## MEMORANDUM

SUBJECT: **PUD-1-14 PRELIMINARY PLAN: THE ESTATES (FINDINGS OF FACT)**

## PUD PRELIMINARY PLAN

Not For Construction  
**PRELIMINARY PLAN**

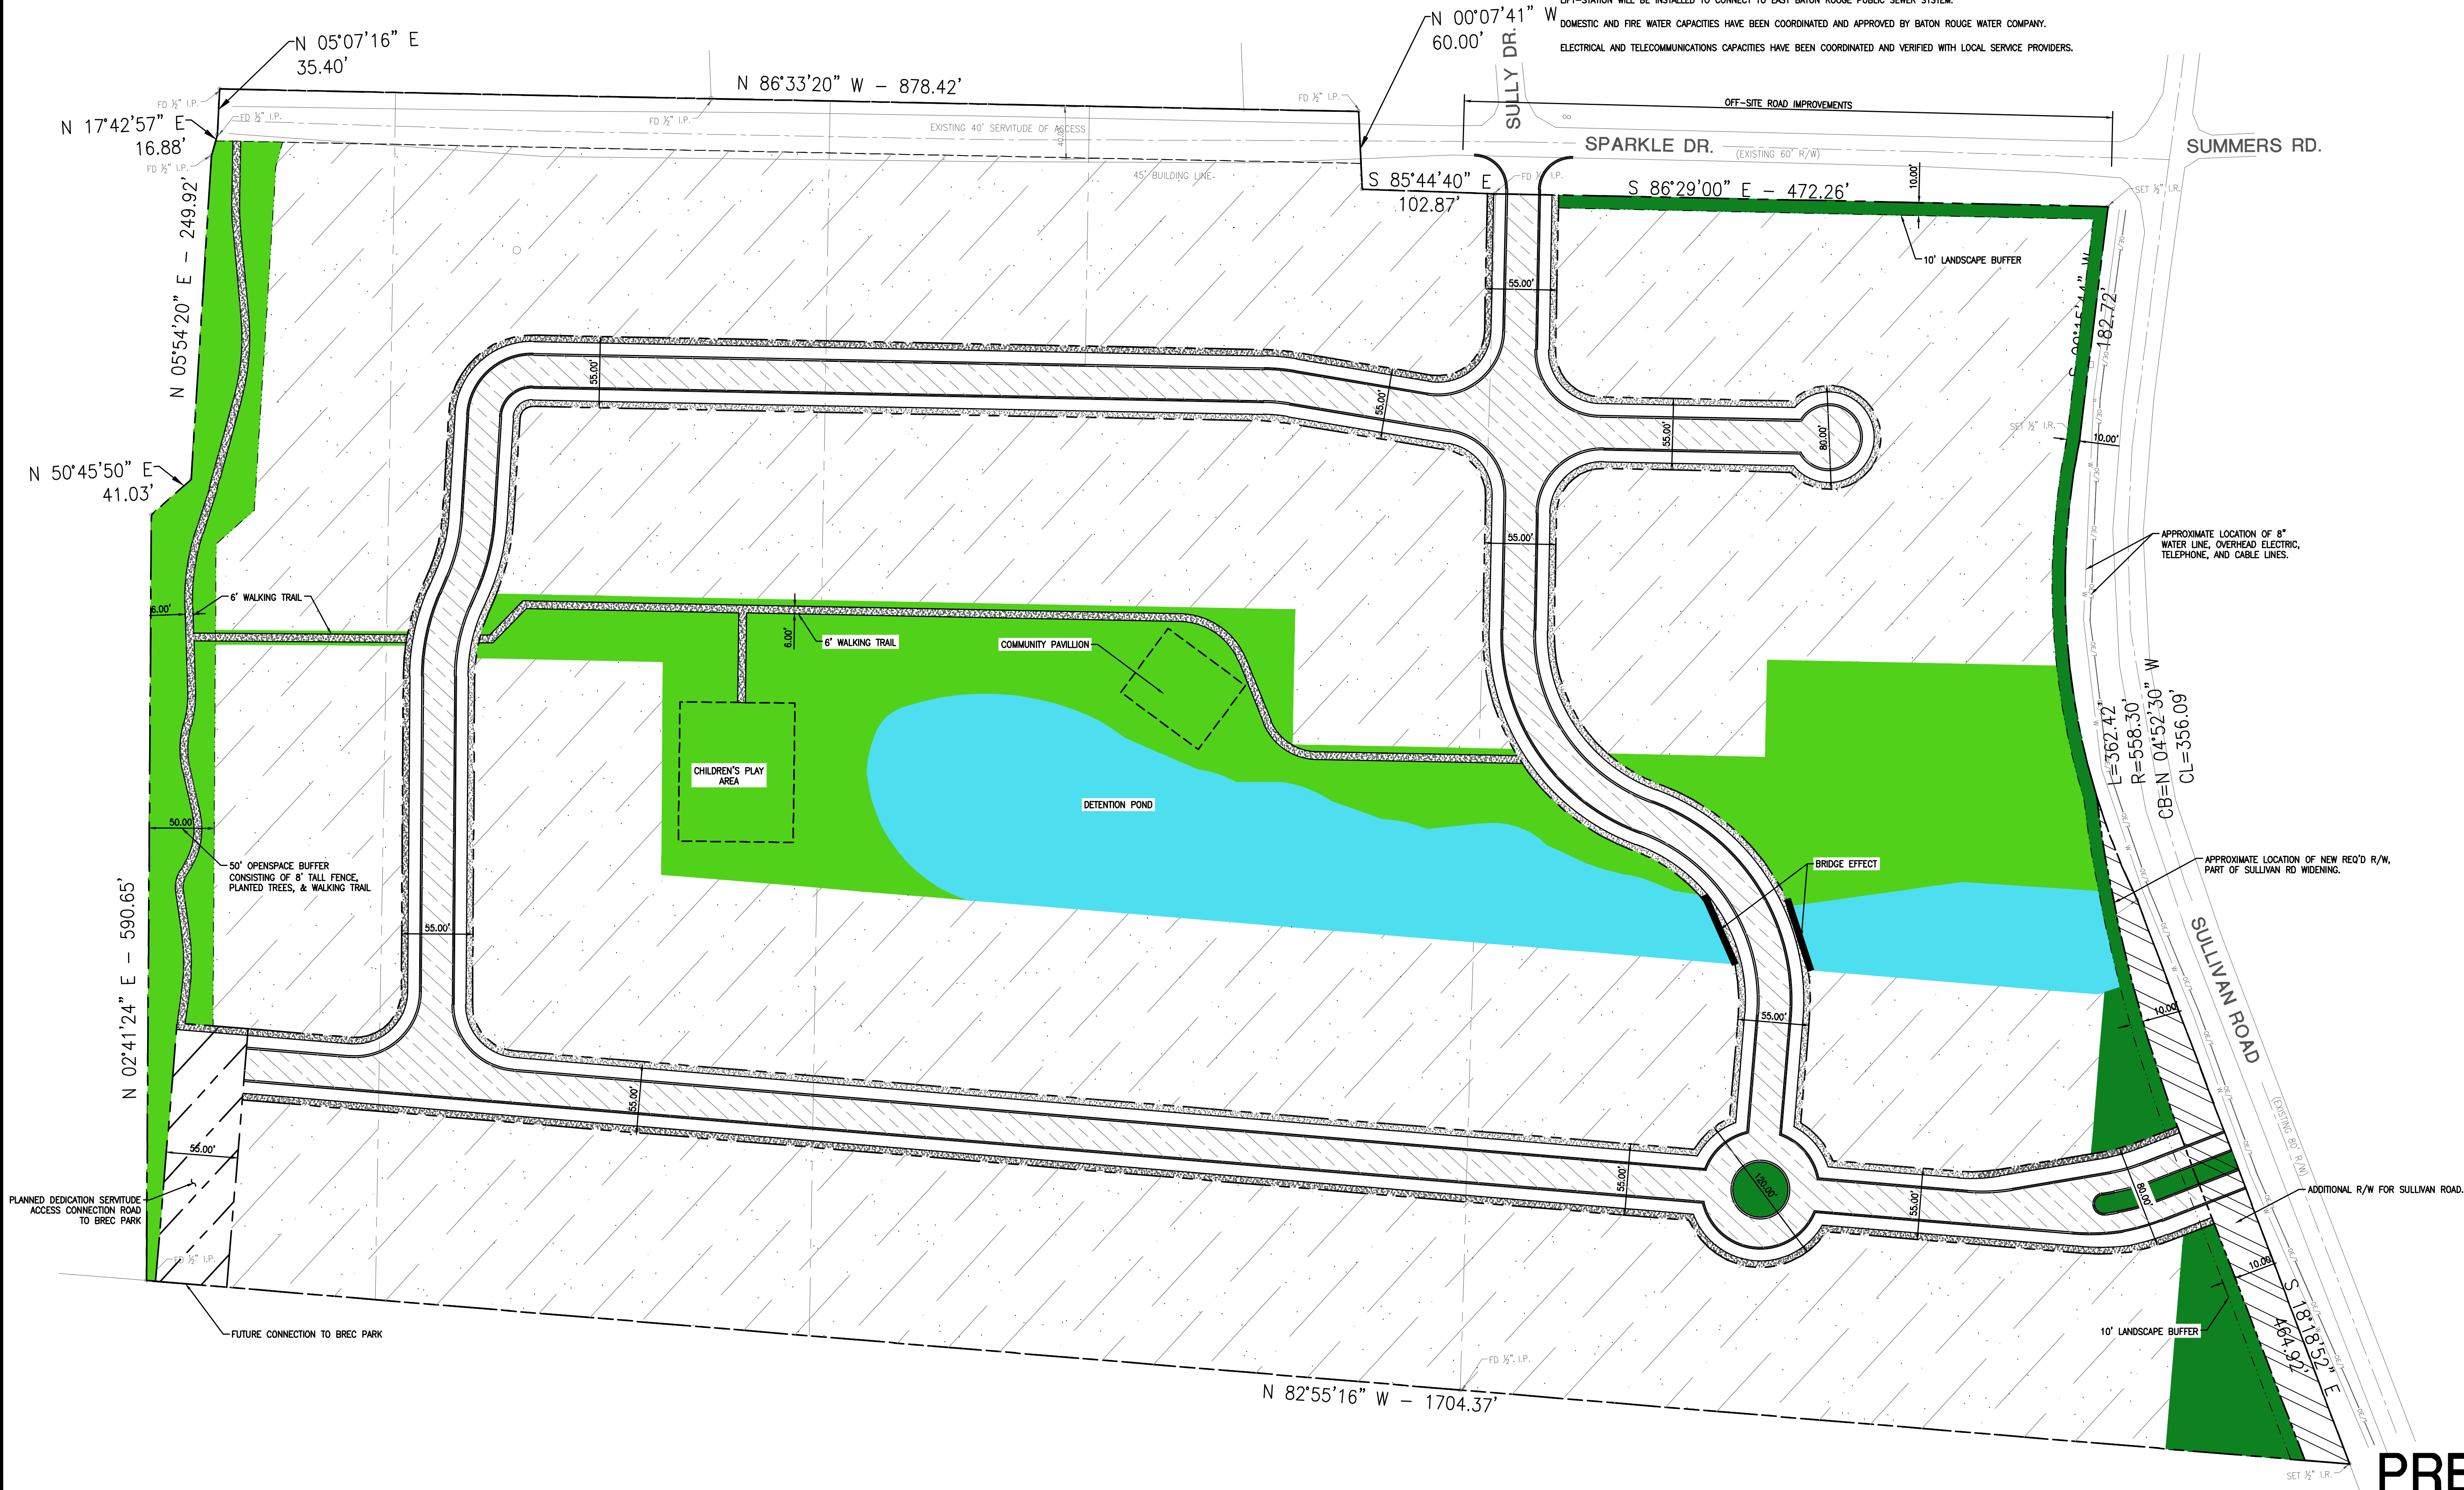
- c. According to the recommended open space standards, not all the area shown in gray would be acceptable as required open space. As shown on the map, only about 2.5 acres would be allowable which falls short of the required 3.3 acres. The areas along Sullivan and proposed ROWs and in several places around the pond are too narrow to qualify as open space. Consider pedestrian route on all sides of detention pond. **(Applicant has resolved this comment.)**

3. According to the recommended open space standards, not all the area shown in gray would be acceptable as required open space. As shown on the map, only about 2.5 acres would be allowable which falls short of the required 3.3 acres. The areas along Sullivan and proposed ROWs and in several places around the pond are too narrow to qualify as open space. Consider pedestrian route on all sides of detention pond. Open space areas have been adjusted per request to meet code.
